REMARKS

Changes in the Drawings:

Amendments to the Drawings:

FIG. 1
PRIOR ART

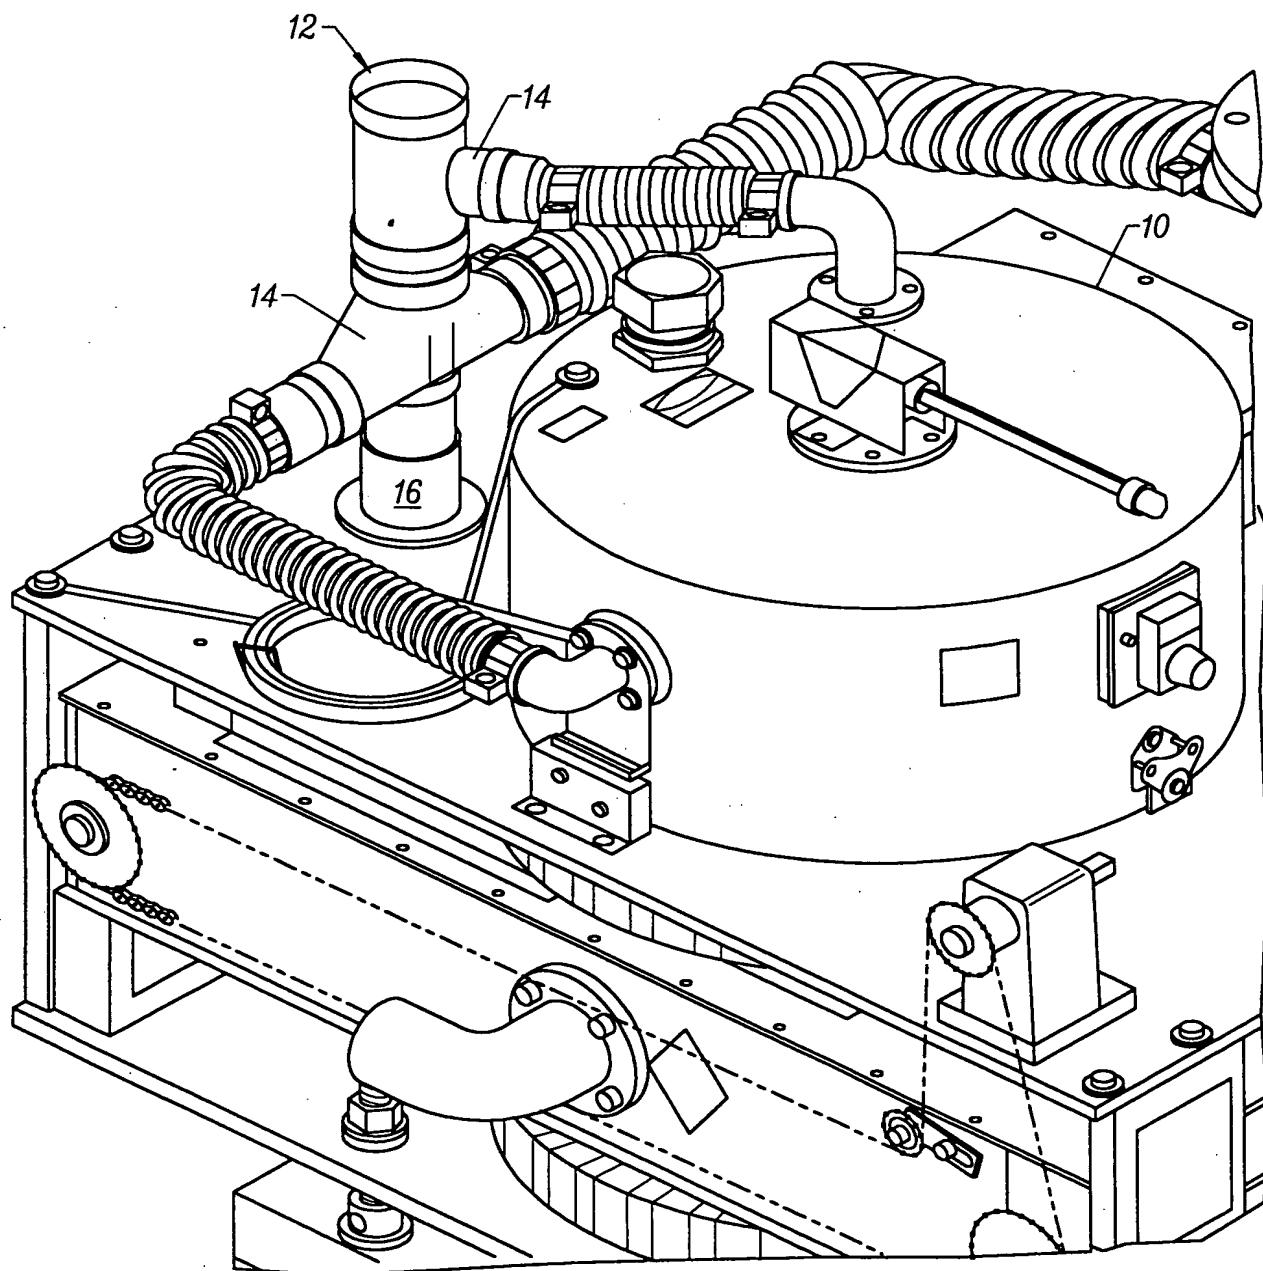
FIGS. 1 and 2 stand objected to on the grounds that the legend "Prior Art" is missing. FIGS. 1 and 2 have been amended to designate FIGS. 1 and 2 with the legend "Prior Art."

Corrections are indicated in red ink on the annotated sheet showing changes.
